CR270 – Front Speed Sensor Cable Fixing Update

Diavel V4 Model Year 2023-2024 (all versions)
Technical Service Bulletin SRV-TSB-24-007

Technical Service Bulletin SRV-TSB-24-007

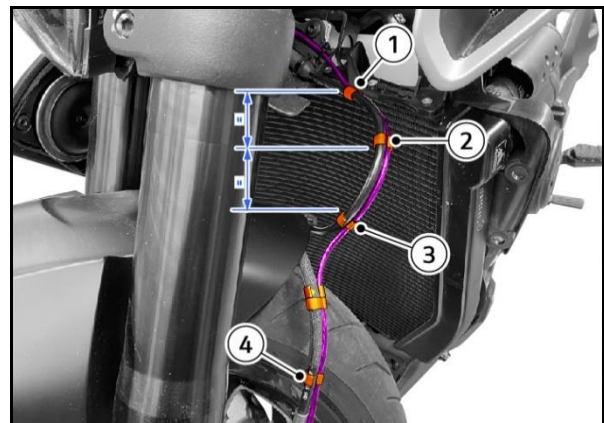
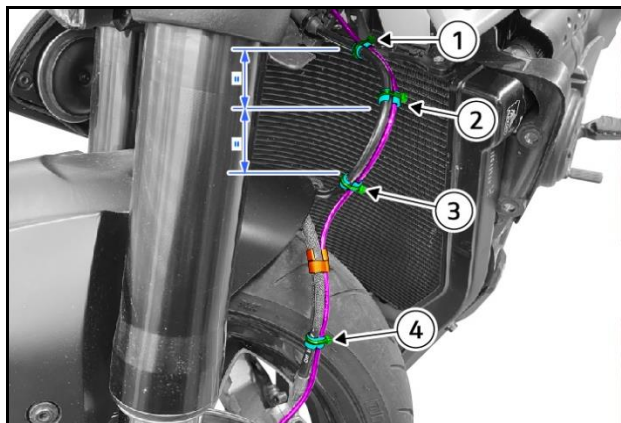
Ongoing quality inspections revealed the need to update the fixing of the Front Speed Sensor Cable to the Front Brake Hose. At a specific point of the fixing, **it is necessary to add 2 clips part no. 75812072A opposite each other.**

At the same time as this update, we ask you to check the correct positioning of all clips fixing the front speed sensor cable to the front brake hose.

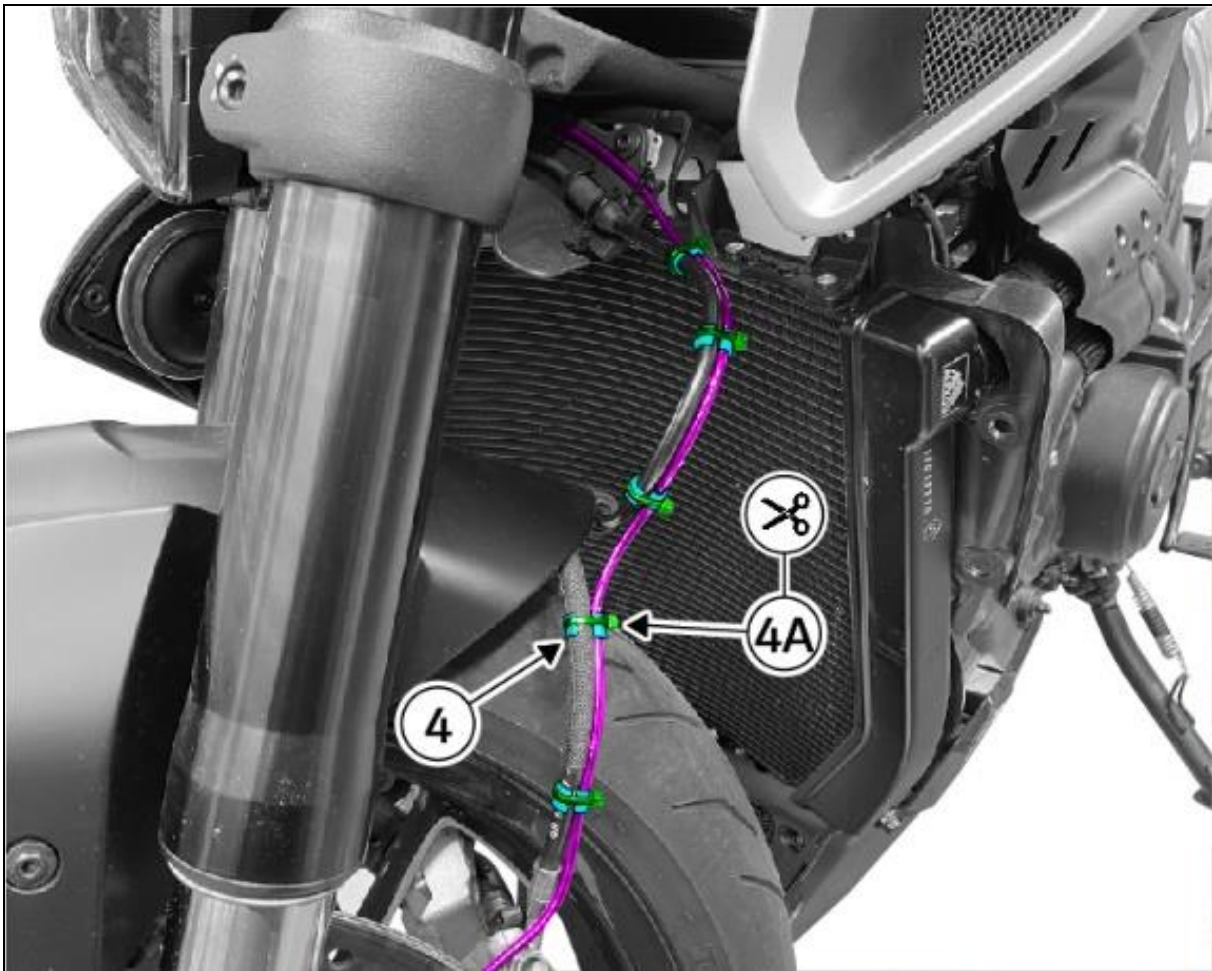
1. Cut the self-locking tie (4A) and remove the cable ring (4).

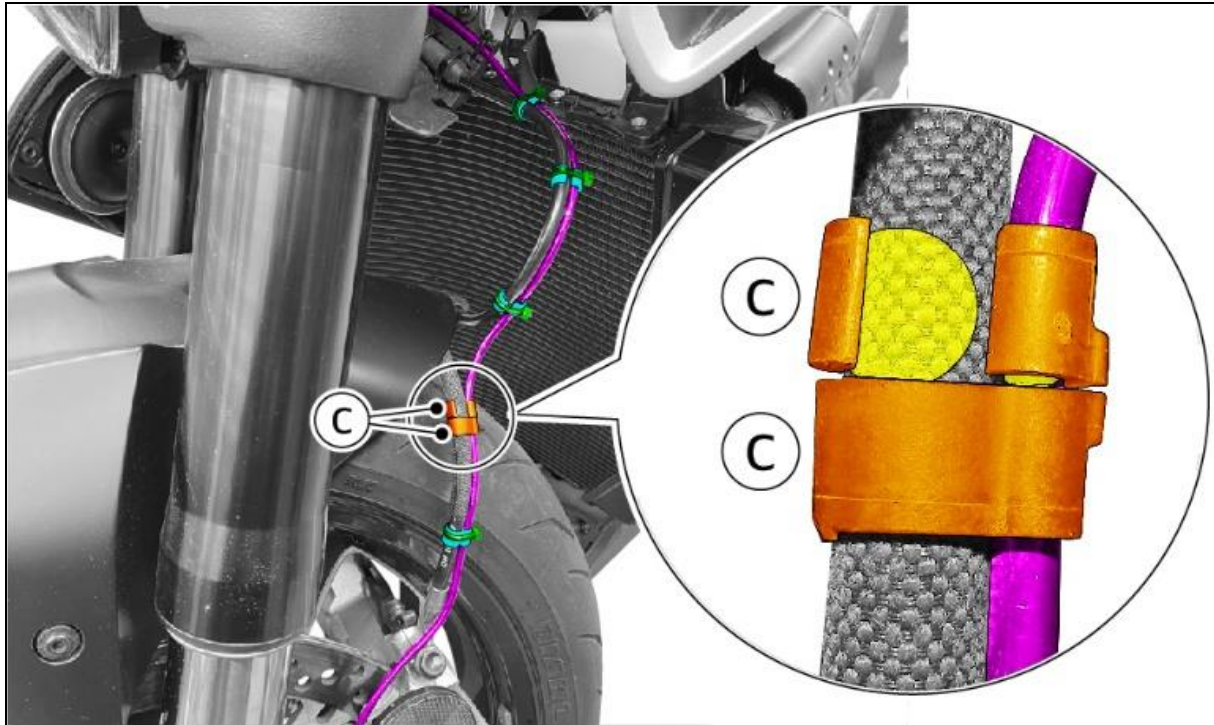
2. Position the **2 new cable rings (C) part no. 75812072A opposite each other**, as shown in the figure.

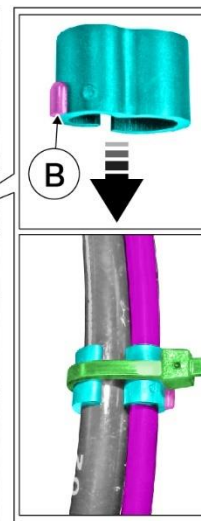
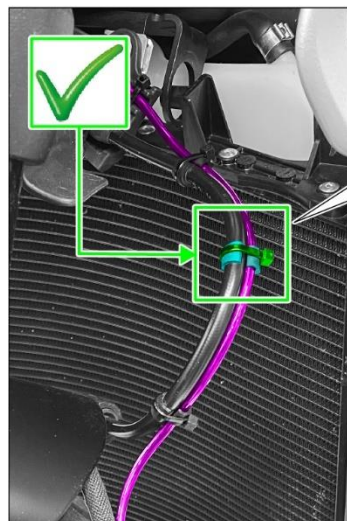
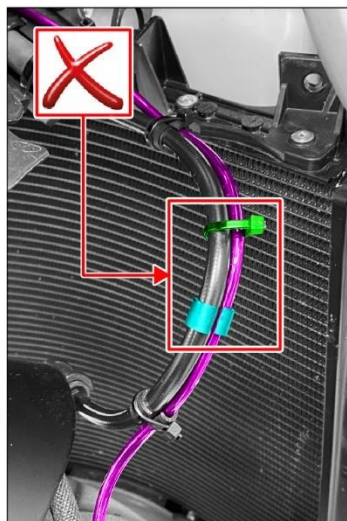
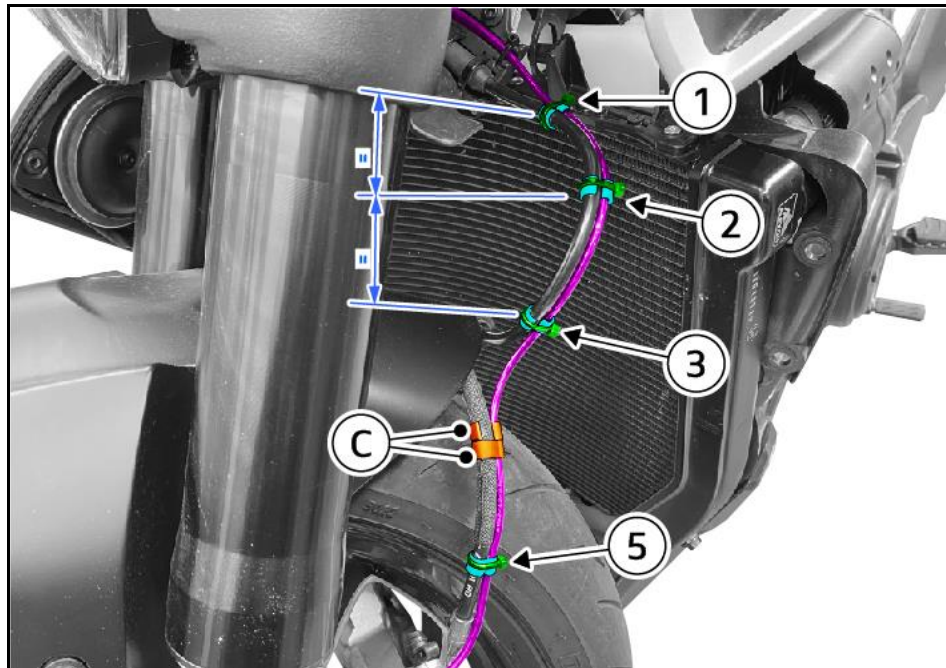
3. Check that the self-locking ties are correctly positioned on the cable rings.

Check the position of the **cable rings (1), (2), (3) and (5)** and make sure that they have the **notch (B)** facing downwards, so that the relative self-locking ties cannot slip out.

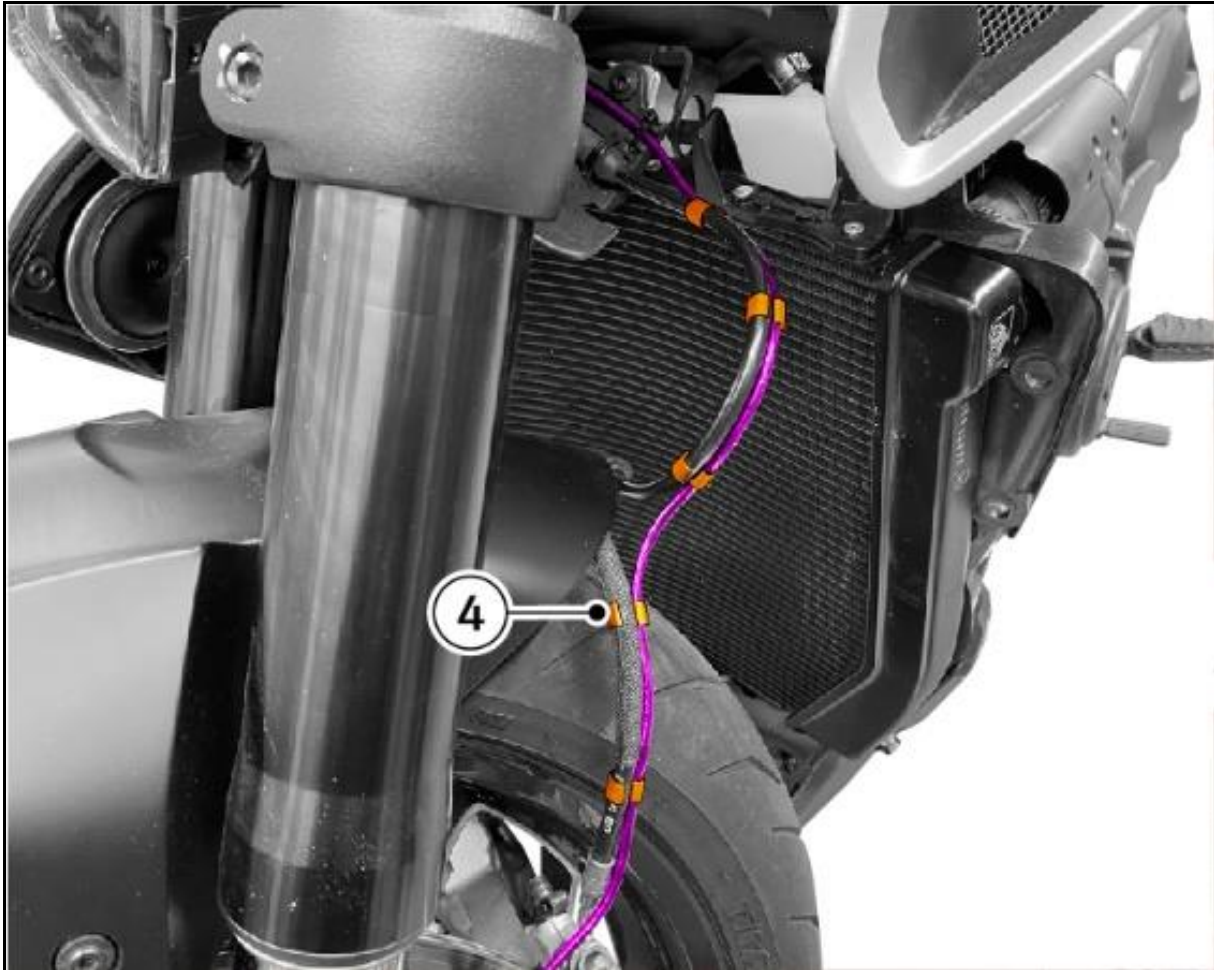
1. Remove the **cable ring (4)**.

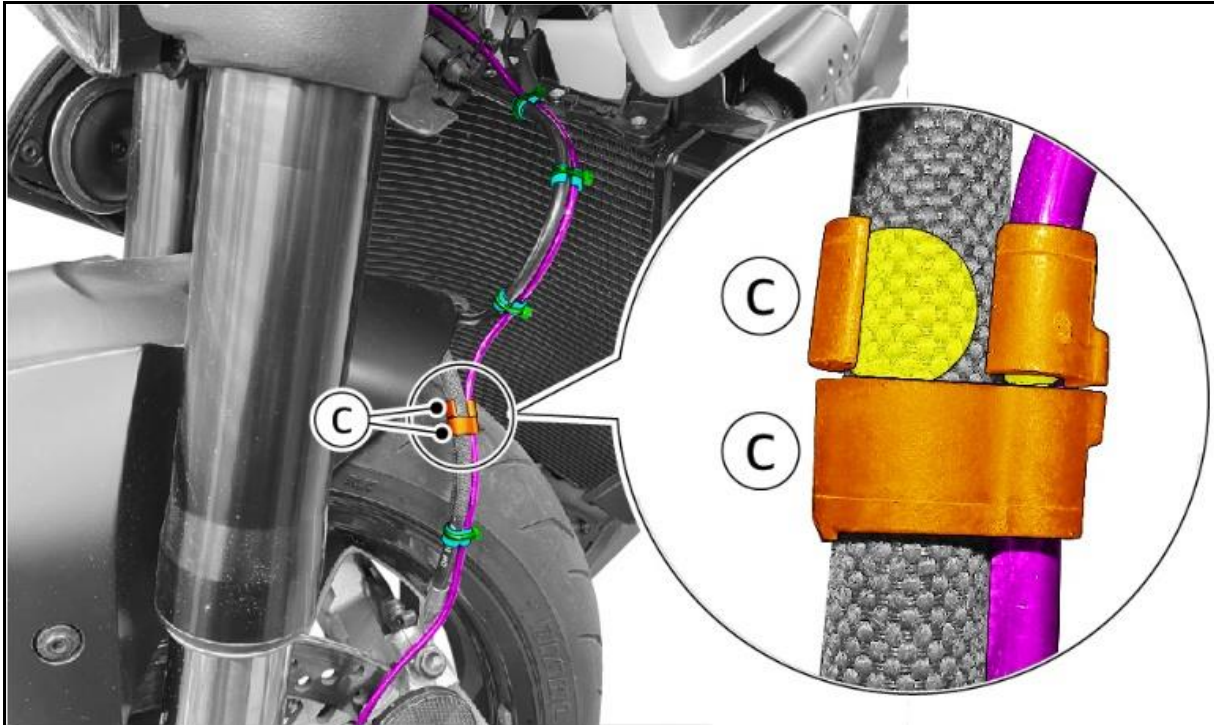
2. Position the **2 new cable rings (C) part no. 75812072A opposite each other**, as shown in the figure.

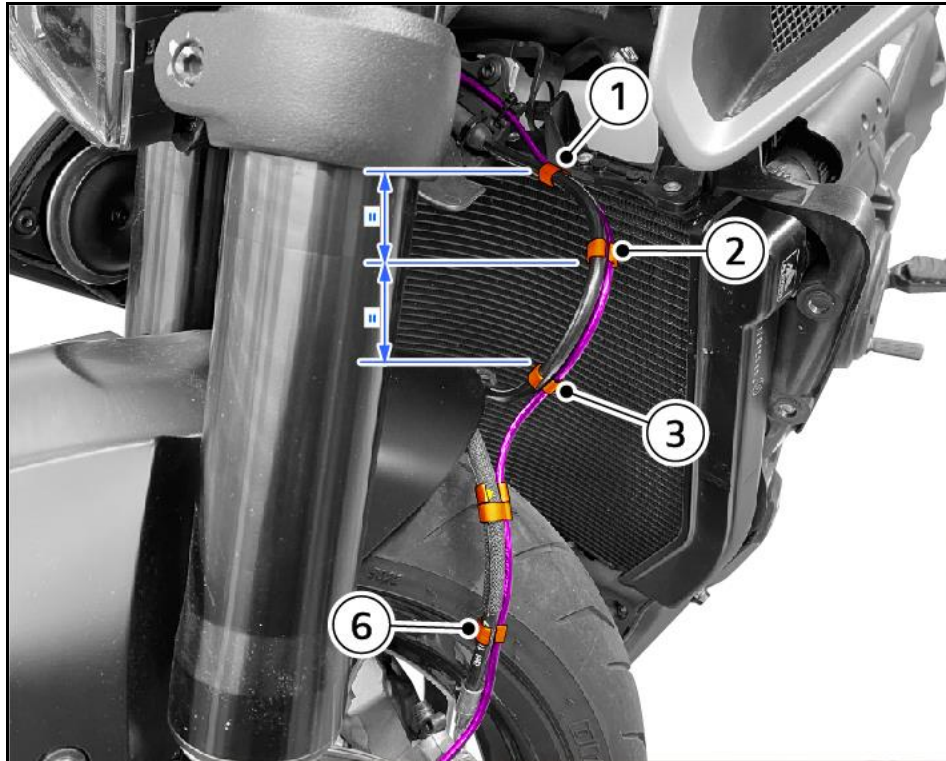
3. Check the correct position of the cable rings (1), (2), (3) and (6).
